**METROPOLITAN GOVERNMENT OF NASHVILLE AND DAVIDSON COUNTY**

**STAFF RECOMMENDATION**  
**1315 Lillian Street**  
**February 18, 2015**

**Application:** New construction - infill  
**District:** Lockeland Springs-East End Neighborhood Conservation Zoning Overlay  
**Council District:** 06  
**Map and Parcel Number:** 08313054900  
**Applicant:** Teresa Prince  
**Project Lead:** Sean Alexander, sean.alexander@nashville.gov

**Description of Project:** The applicant proposes to construct a one and one-half story house on a vacant lot.

**SITE PLAN  
LOT 2  
RESUBDIVISION OF LOTS 109 & 110  
EAST EDGEFIELD  
SUBDIVISION  
FOR  
ED GAW**

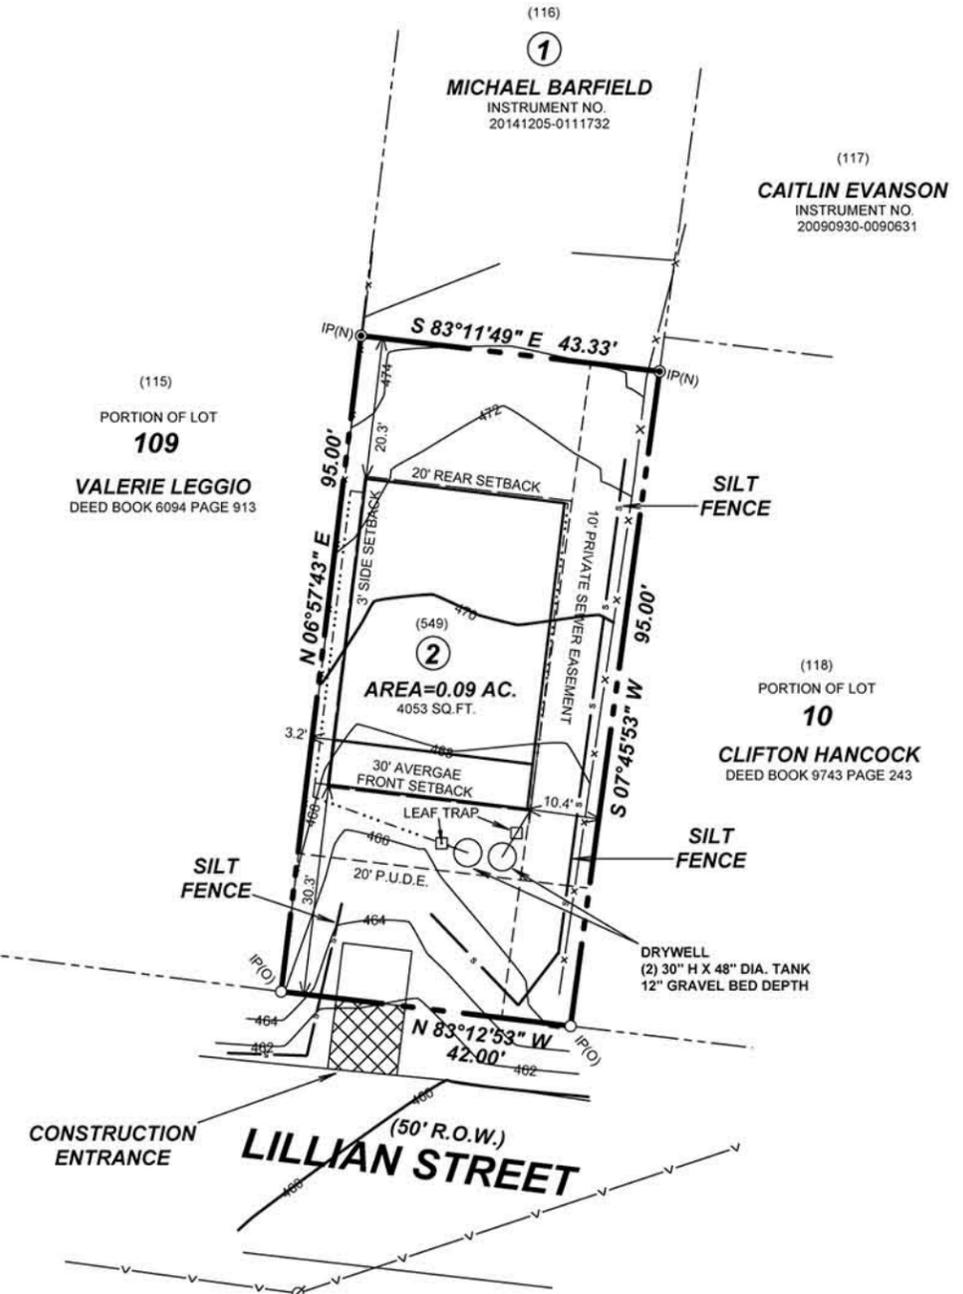
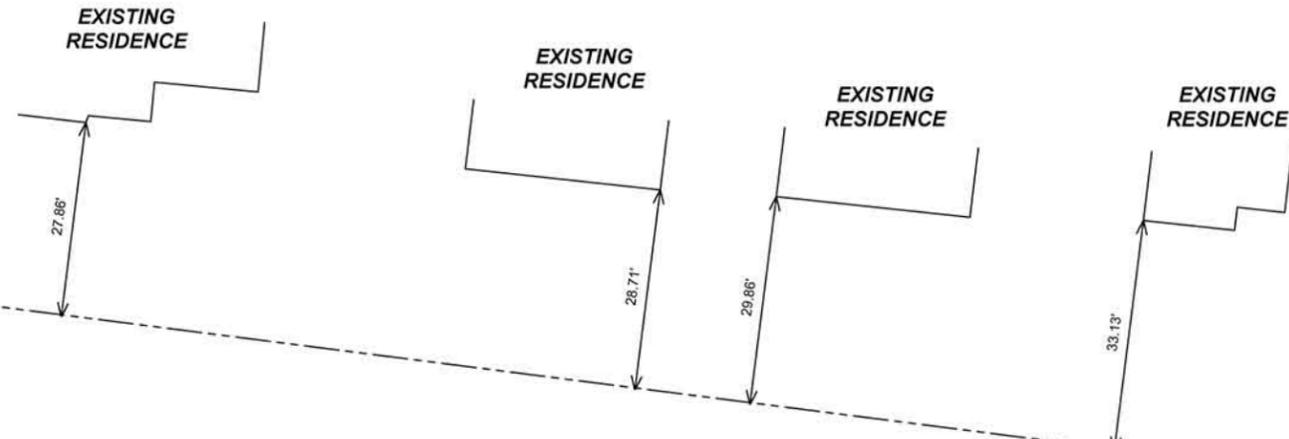
The building will have a front setback of approximately thirty feet (30'). Prior to construction, Staff will verify that this is in line with nearby historic structures. The left side setback will be three feet, three inches (3'-3"), which is an appropriate setback given the context and the size of the lot. The right side setback will be ten feet, four inches (10'-4"). The building is off center to accommodate a sewer easement. This setback meets bulk zoning requirements and is consistent with the rhythm established by existing houses on the street. Staff finds that the project will meet guideline II.B.1.3.

The new structure will be aligned with the front elevation parallel to Lillian Street with a six foot (6') deep full-width porch on the front facade. The site plan does not show a walkway from the front porch to the street as would be typical of houses in the surrounding area. No off-street parking is proposed, and would need to be coordinated with Staff at a later time. With a walkway added to connect the house to the street and any off-street parking approved by Staff, Staff finds that the orientation of the proposed infill will be compatible with surrounding historic houses and will meet section II.B.6 of the design guidelines.

The location of the HVAC and other utilities was not indicated on the drawings. The HVAC should be located on the rear façade or on a side façade beyond the midpoint of the house in order to meet section II.B.9.

- Staff verifies that the front setback is compatible with surrounding houses;
- Staff verifies that the floor height is compatible with surrounding historic houses;
- The window and door selections are approved by Staff;
- The roof color is approved by Staff;
- That there is a front walkway, and any off-street parking is approved by Staff;
- The HVAC is located behind the structure or on the sides, beyond the mid-point of the structure.

1 FRONT ELEVATION  
1/4" = 1'-0"

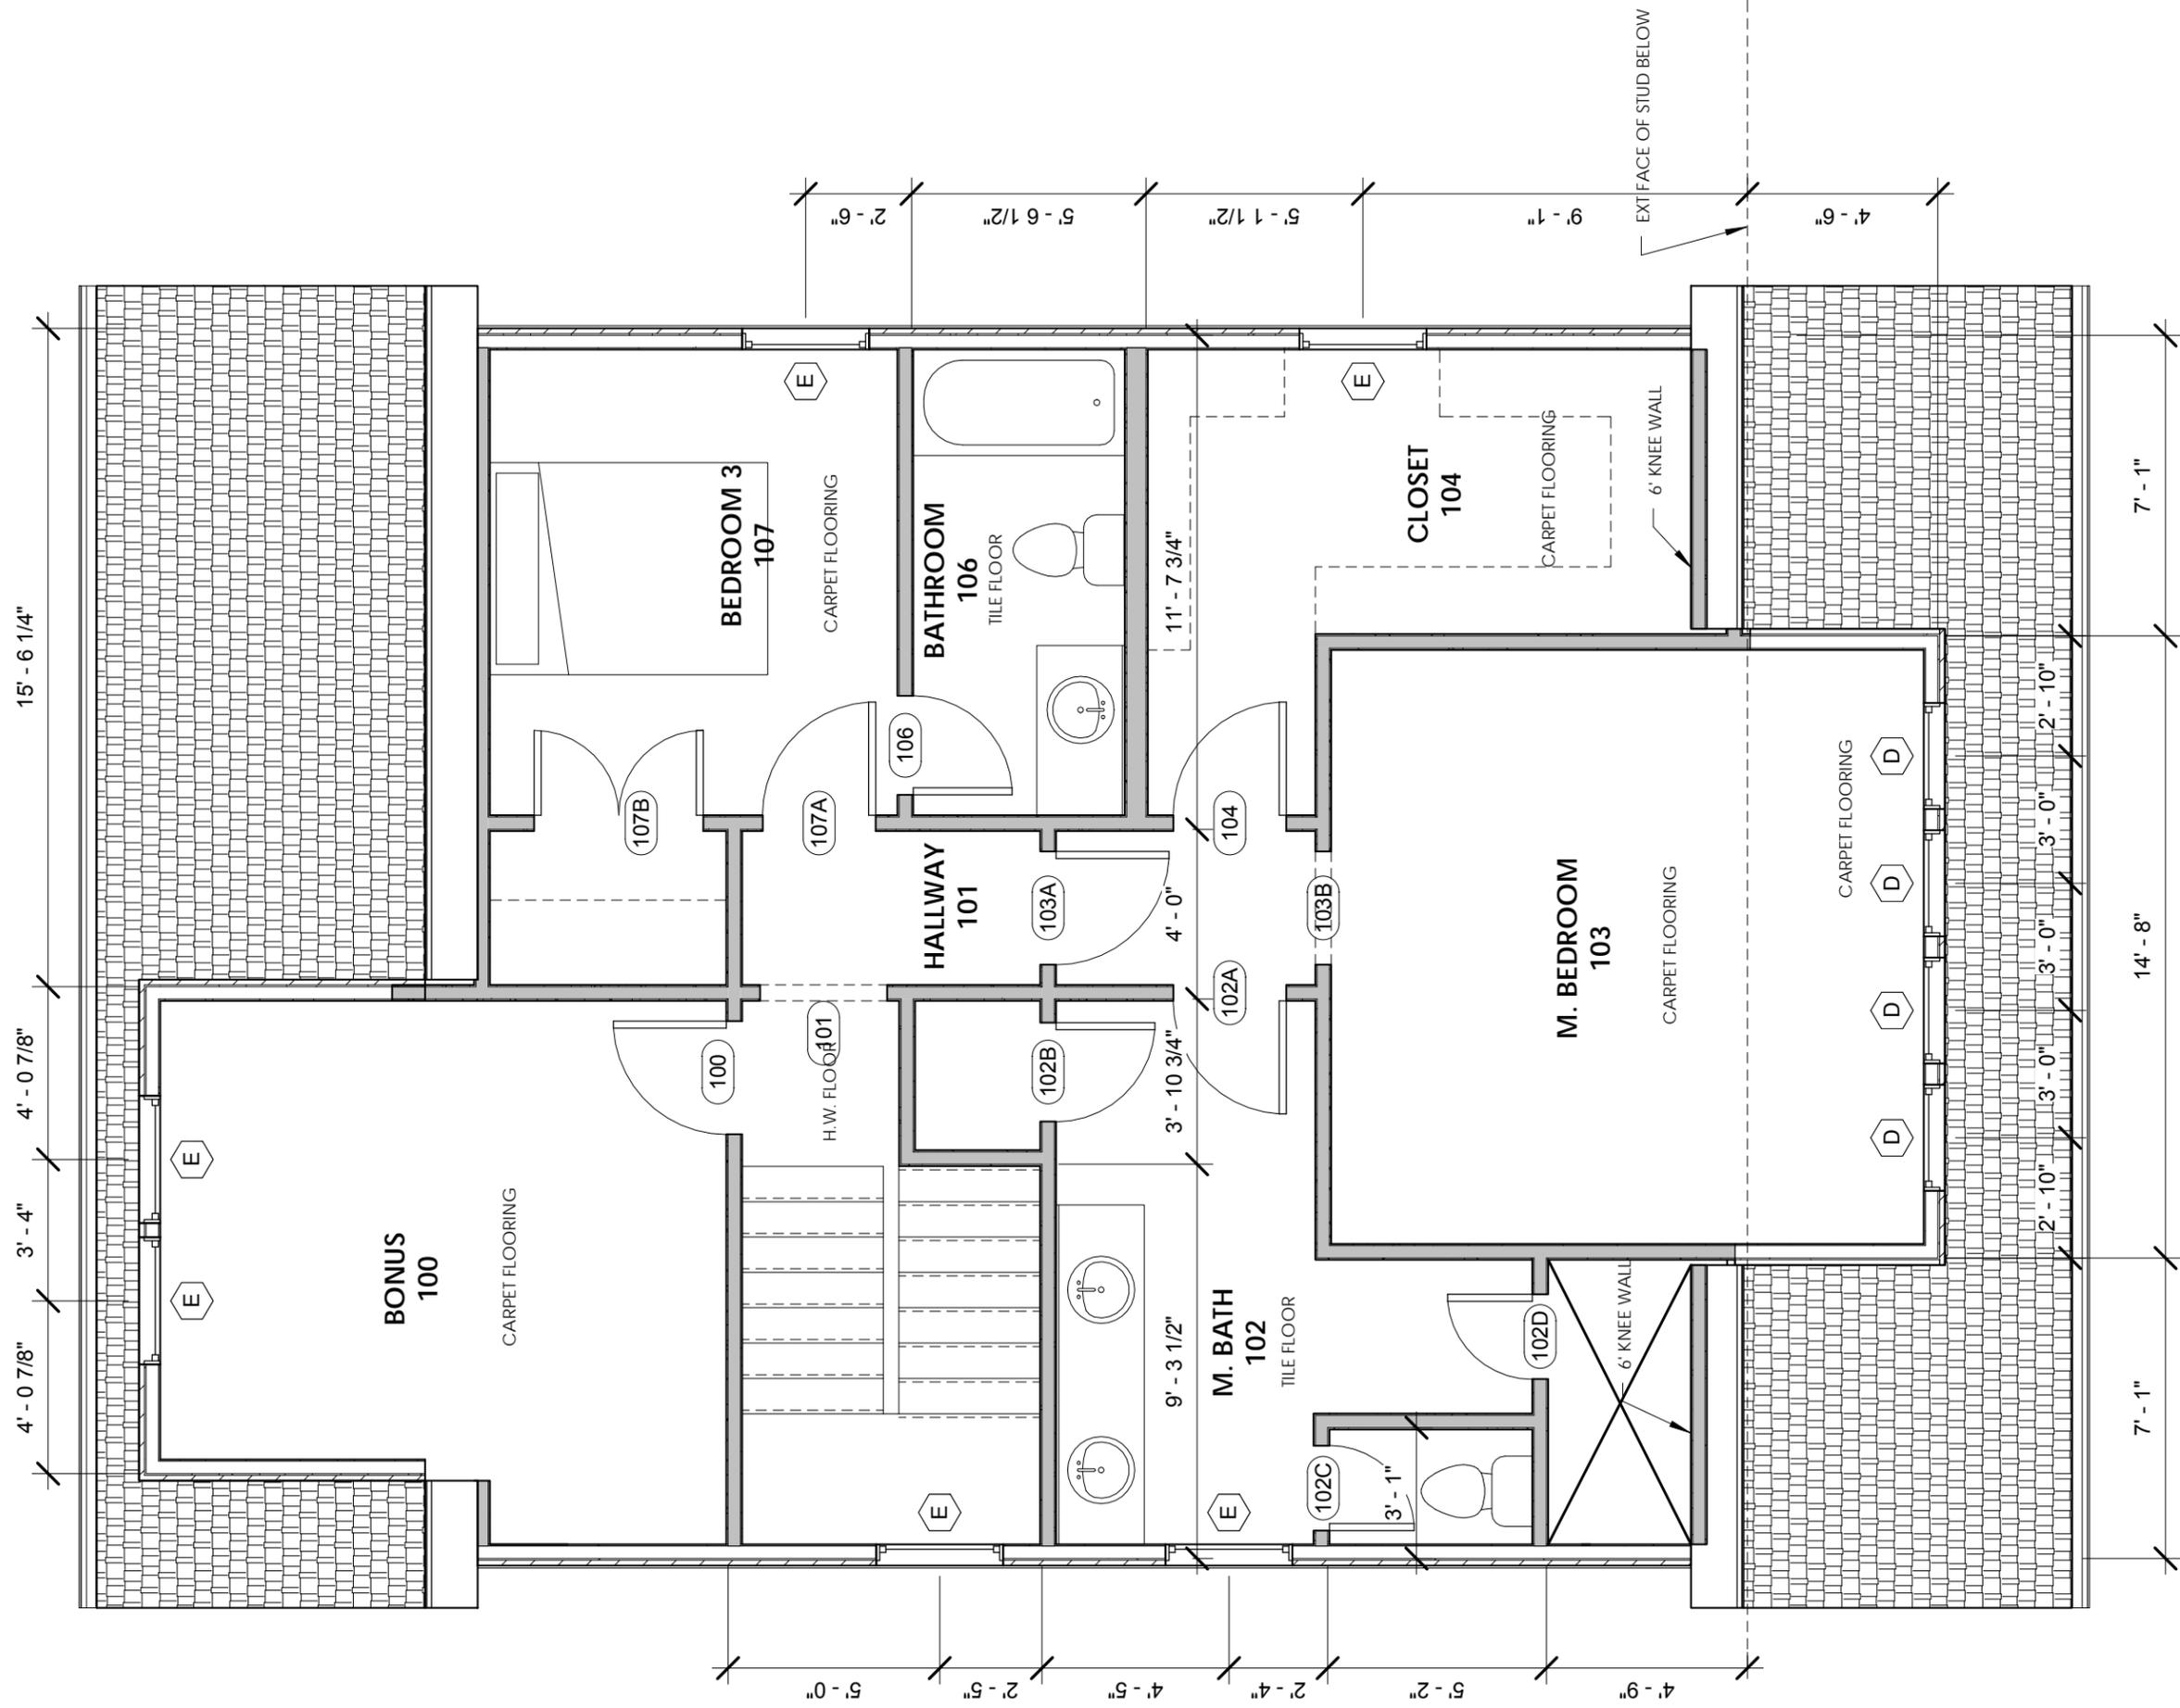
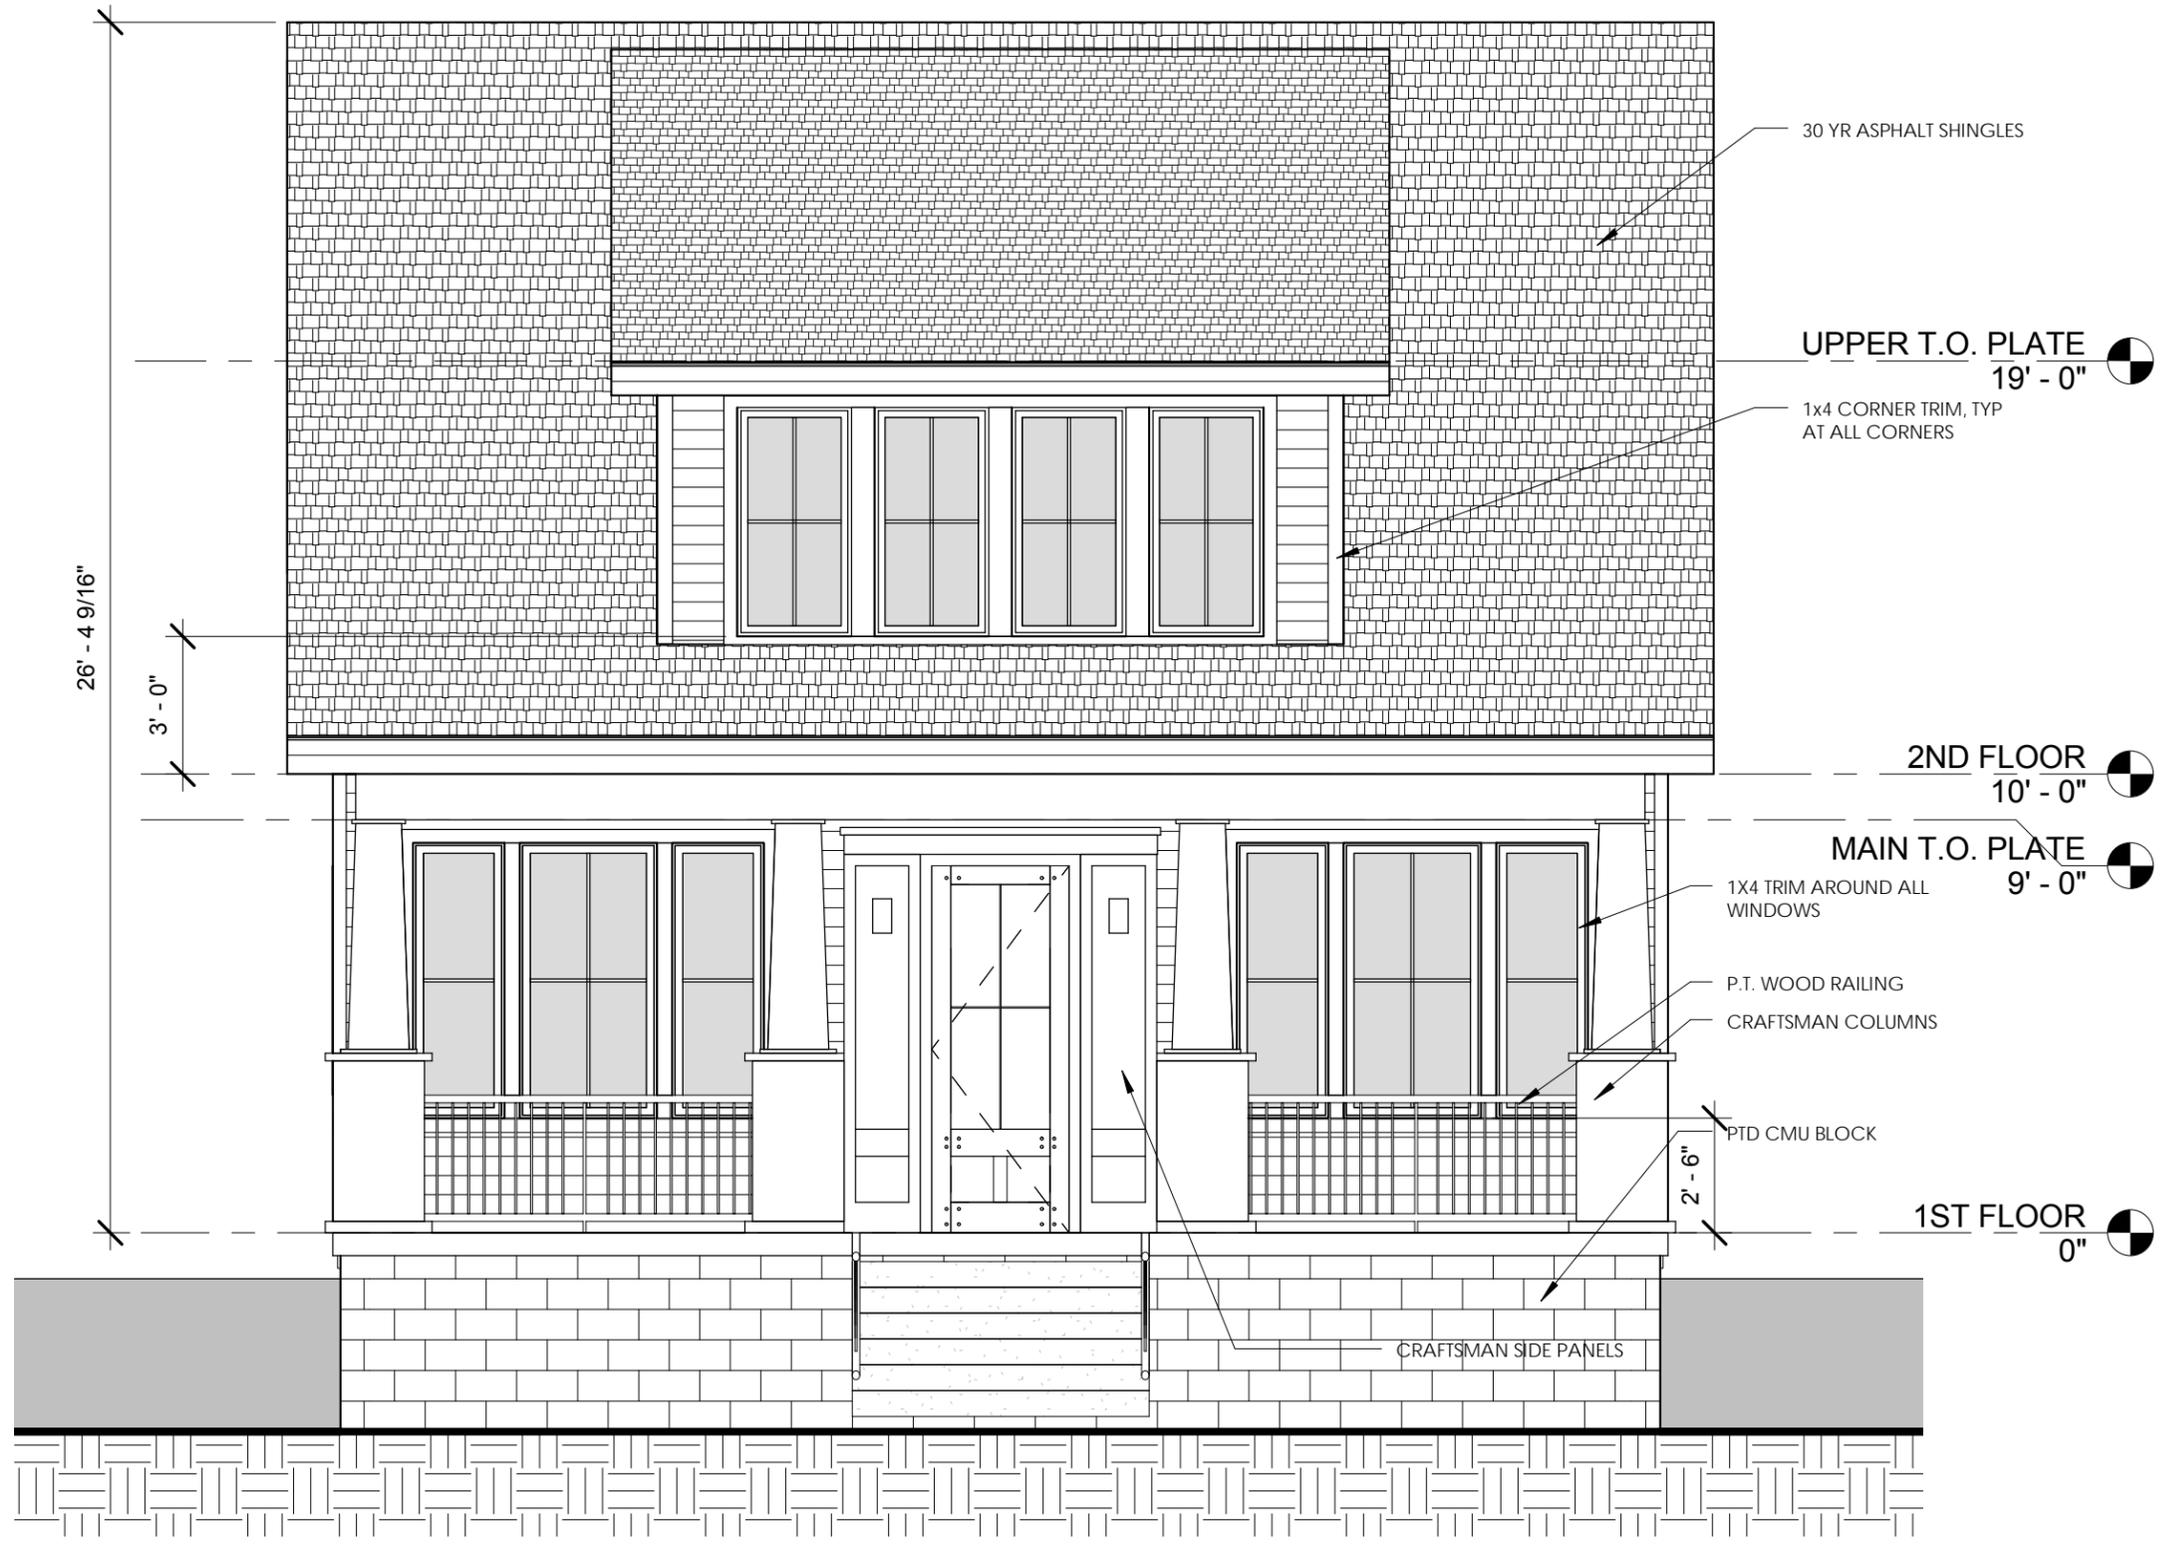
The new building will be one and one-half stories tall with a roof height of twenty-four feet, six inches (24'-6") above the finished floor level and an eave height nine feet (9') above the floor level. The plans show the house having a four foot (4') tall foundation at the front, with the grade rising to cover all but one foot (1') of foundation at the rear. During construction, Staff will verify that the floor height is compatible with surrounding historic houses.

The new building will primarily be clad in smooth-faced cement fiberboard with a reveal of five inches (5"). The trim will be wood and cement-fiberboard. The foundation will be split-faced concrete block and the roof will be asphalt shingles in a gray or brown color. The porch stairs and floor will be concrete, and the porch columns and railings will be wood. The windows and doors will be wood or aluminum-clad, and staff asks to approve the final window and door selections prior to purchase and installation. With the staff's final approval of the brick, the roof color, and the window and door selections, staff finds that the known materials meet Sections II.B.1.d of the design guidelines.

The roof will be a side-facing gable with a pitch of 8:12, with a shed-roofed dormer on the front slope sitting six inches (6") below the primary ridge and two feet (2') back from the first story wall as is typical of historic dormers. Staff finds these roofs to be compatible with those of historic houses nearby and that the project meets section II.B.5 of the design guidelines.

The windows on the proposed new building are all generally twice as tall as they are wide, thereby meeting the historic proportions of openings. There are no large expanses of wall space without a window or door opening. Staff finds the project's proportion and rhythm of openings to meet guideline II.B.7.
